**A RESOLUTION APPROVING A SITE PLAN AND COMMUNITY
IMPACT ASSESSMENT STATEMENT FOR THE PROPOSED KEY
WEST SHOPPING CENTER; PROVIDING AN EFFECTIVE DATE.**

RE: I.D. Properties
CIAS Review Response

Comment Response
For
I.D. Properties
Key West, Florida
Community Impact Assessment Statement

FIG. 3

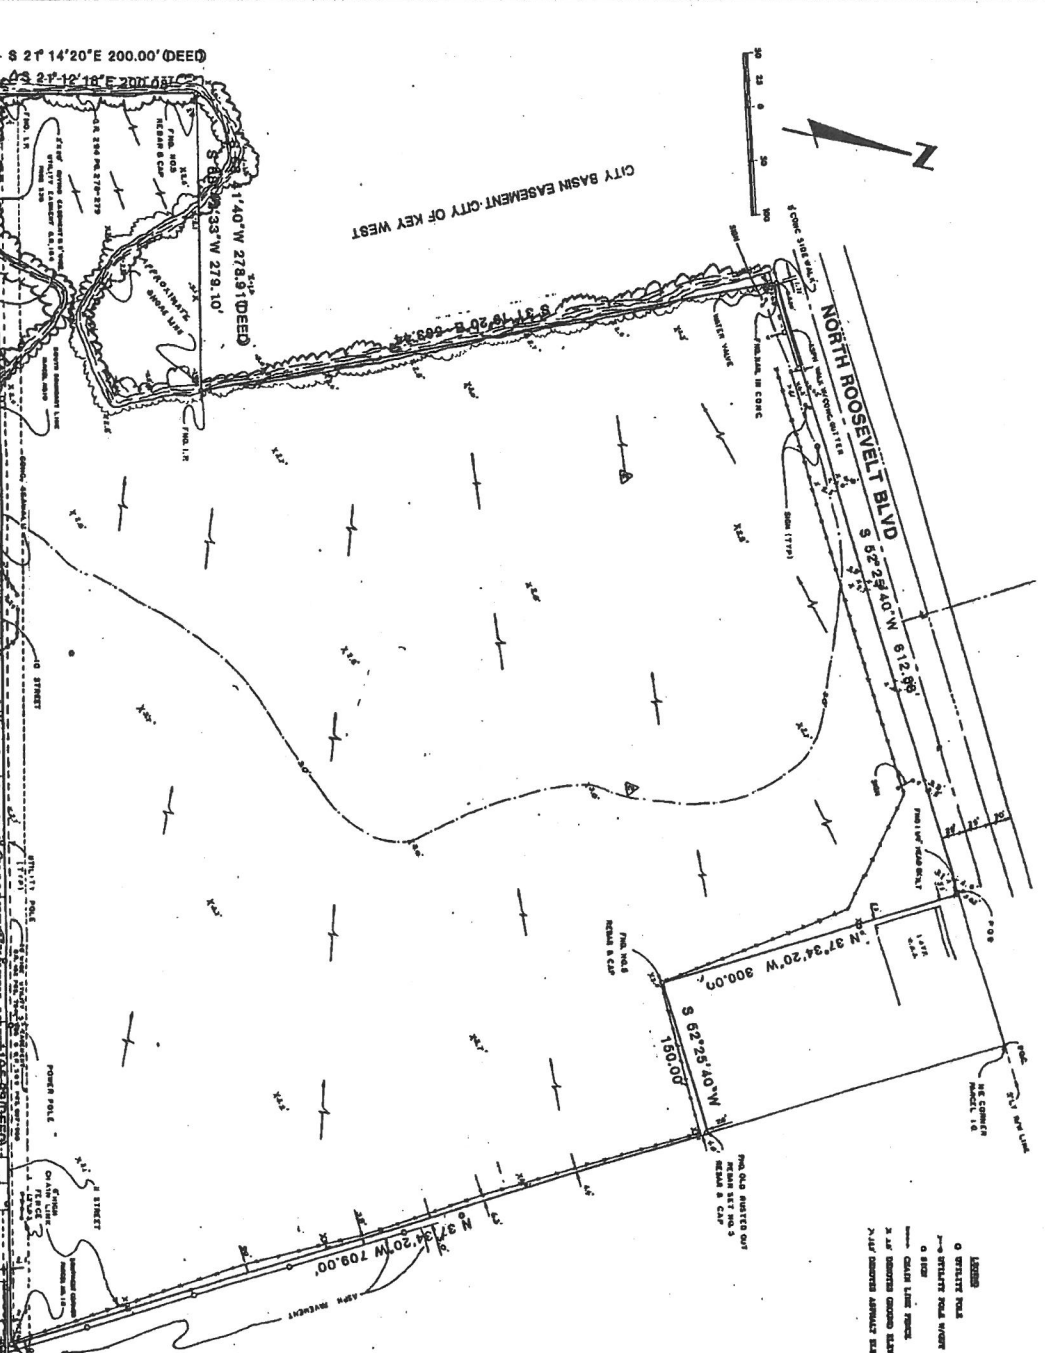
Comment: (a) Delineated 100-year flood-prone areas and existing drainage patterns; map 34.08(a)(3).

Response: We have added one (1) foot contours and surface rainwater runoff pattern to both Figure 3, Page 2-6 and the Boundary and Limited Topographic Survey located in the Plan Pocket, Appendix C of the C.I.A.S. The following note has also been added to both of the above described exhibits:

"The property depicted and described hereon is located in flood zone A10, (Base Flood El. +10.00' N.G.V.D.), as shown on National Flood Insurance Program Flood Insurance Rate Map (FIRM) for Monroe County, Florida community - Panel No. 120168-0004B, dated 11/2/83."

ELEVATION FIG. 11

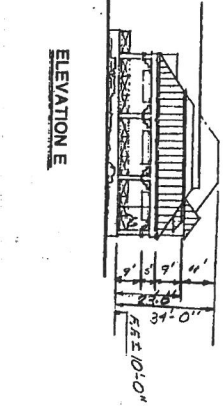
Comment: (b) Explanation of building elevation drawings; the elevations shown appear to violate the building height restrictions.

Comment: The building height for this project is 40 feet maximum measured from the crown of the nearest adjacent road. This will require a corrected architectural elevations drawing.

Response: Both of the exhibits showing the projects elevations (Exhibit Fig. 11, Page 2-14 and the large scale drawing located in the Plan Pocket, Appendix C) have been corrected to show a maximum building height of 34'-0" (Elevation +44.0') above finished floor (Elevation +10.0'). The average roadway elevation of Roosevelt Boulevard is assumed to be elevation +4.5' allowing a 40'-0" building height to elevation +44.5'.

Response: The elevation drawings (both Figure 11, Page 2-14 and the large scale elevation drawing) have been revised so that the maximum building heights is now 34'-0" (Elev. +44.0') above finished floor (Elev. +10.0').

LANDSCAPING
PLAN
FIG. 9

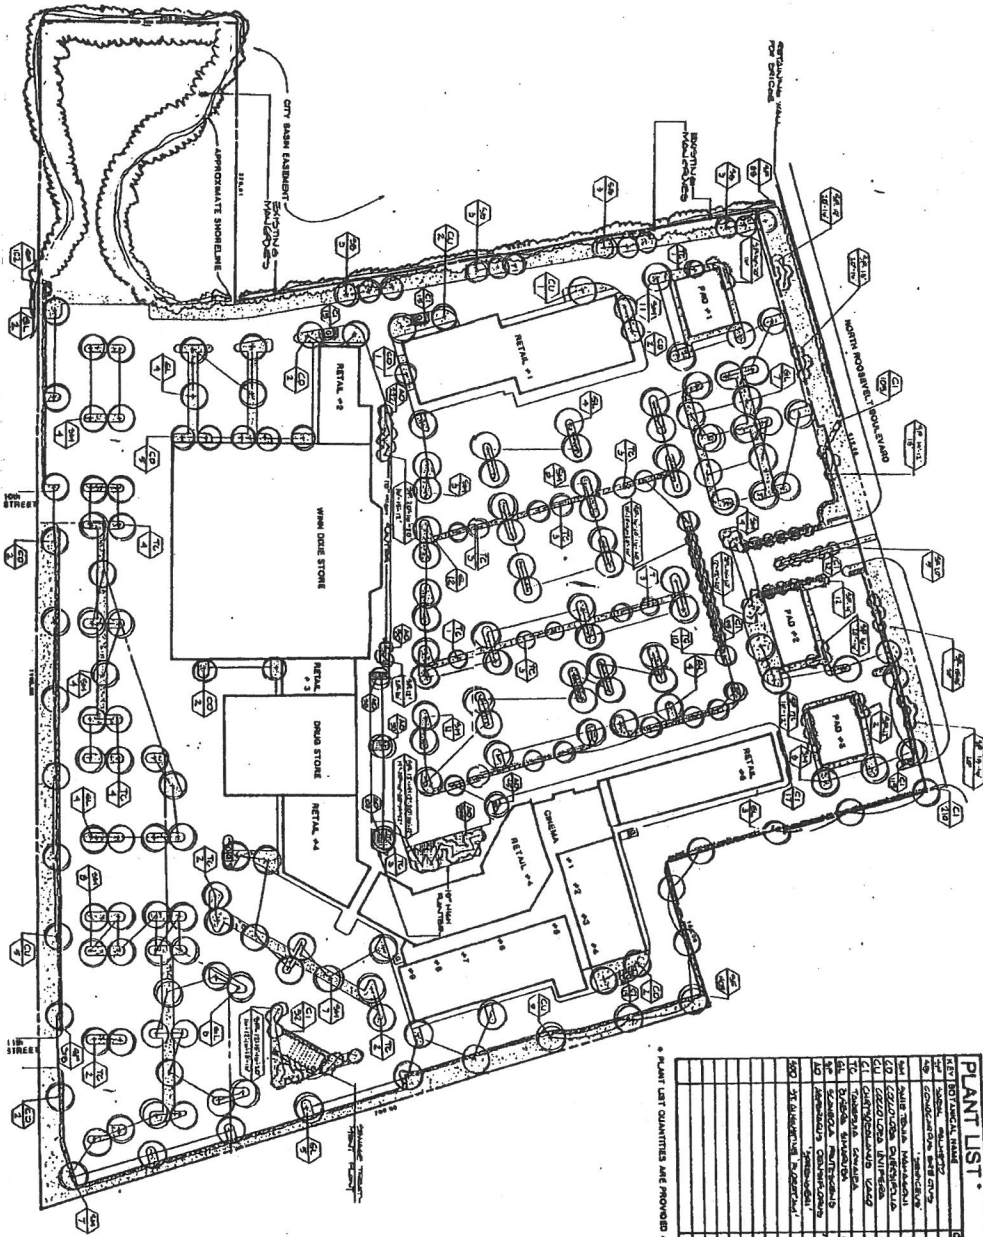
Comment: (d) A natural vegetation map if the site includes wetland communities; map 34.08(a)(9).

Response: Both the Landscaping Plan (Fig. 9, Page 2-12) and the large scale Landscaping Plan (Plan Pocket, Appendix C) have been revised to show the wetland vegetation (mangroves) areas.

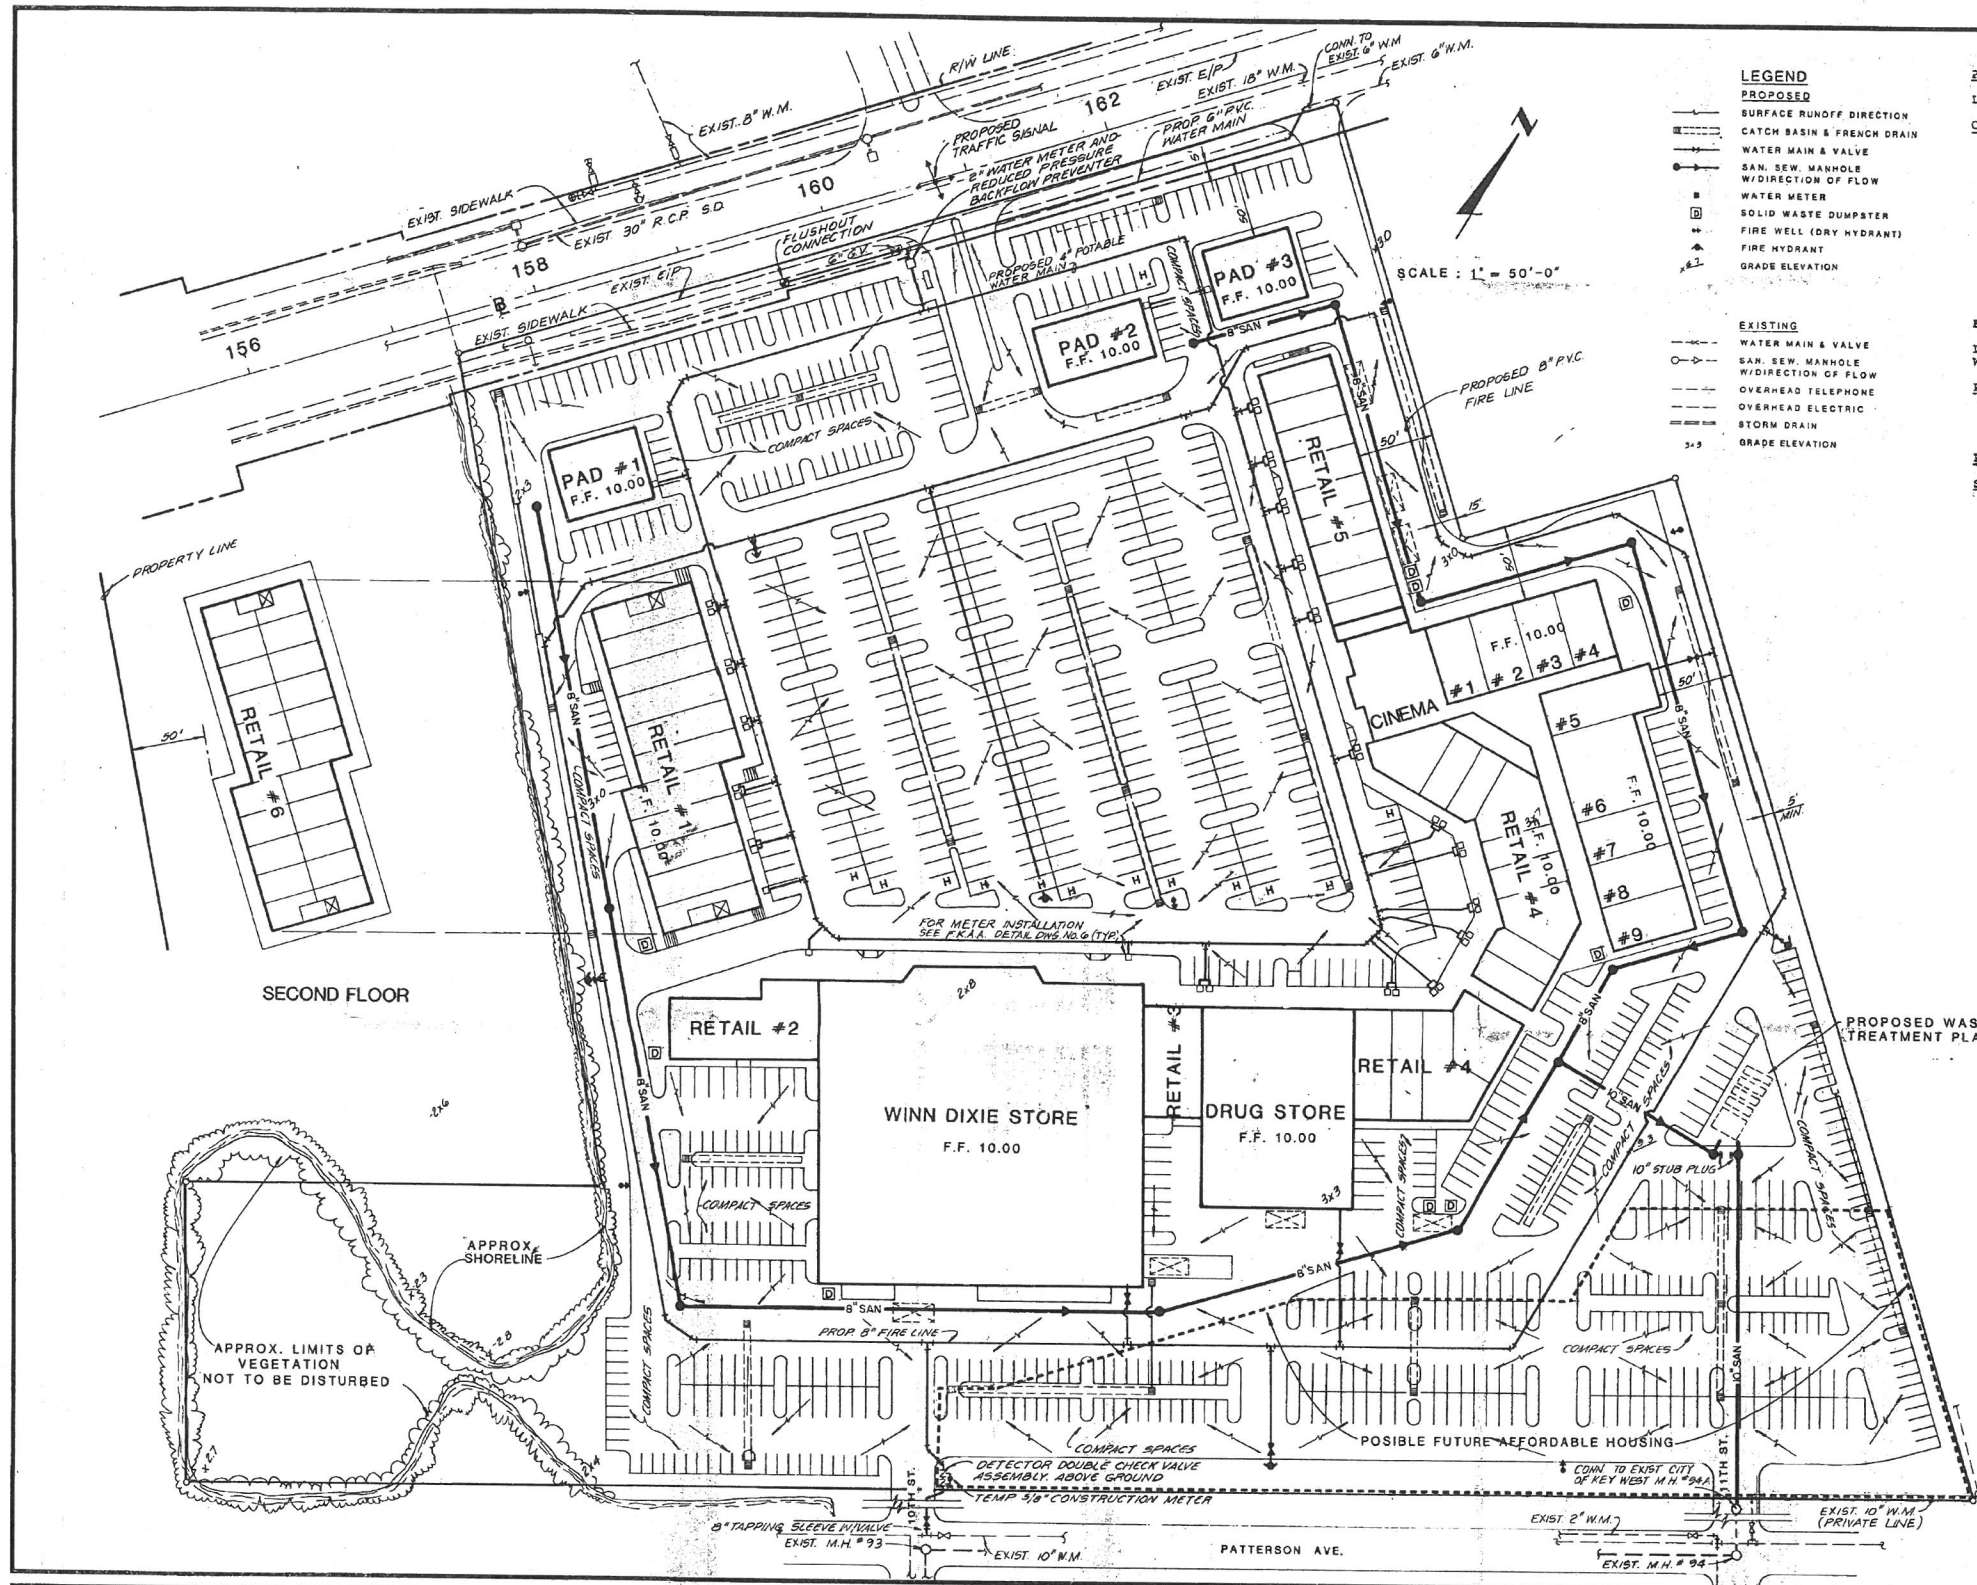
Comment: (c) Explanation of setback of cinemas 1-4; structure appears to be in violation of required setback.

Comment: The setbacks for this project must be a minimum of 50 feet on all sides. This will require a corrected site plan for the cinemas 1-4 structure.

Response: The Preliminary Development Plan (PDP) has been revised to more clearly show the 50' minimum setback to the property lines. It is and has been the intent that all buildings will have a minimum of 50' setback as shown on the P.D.P.

Response: The Preliminary Development Plan (PDP) has been revised to more clearly show the 50' minimum setback required. See Revised P.D.P. included with this response.
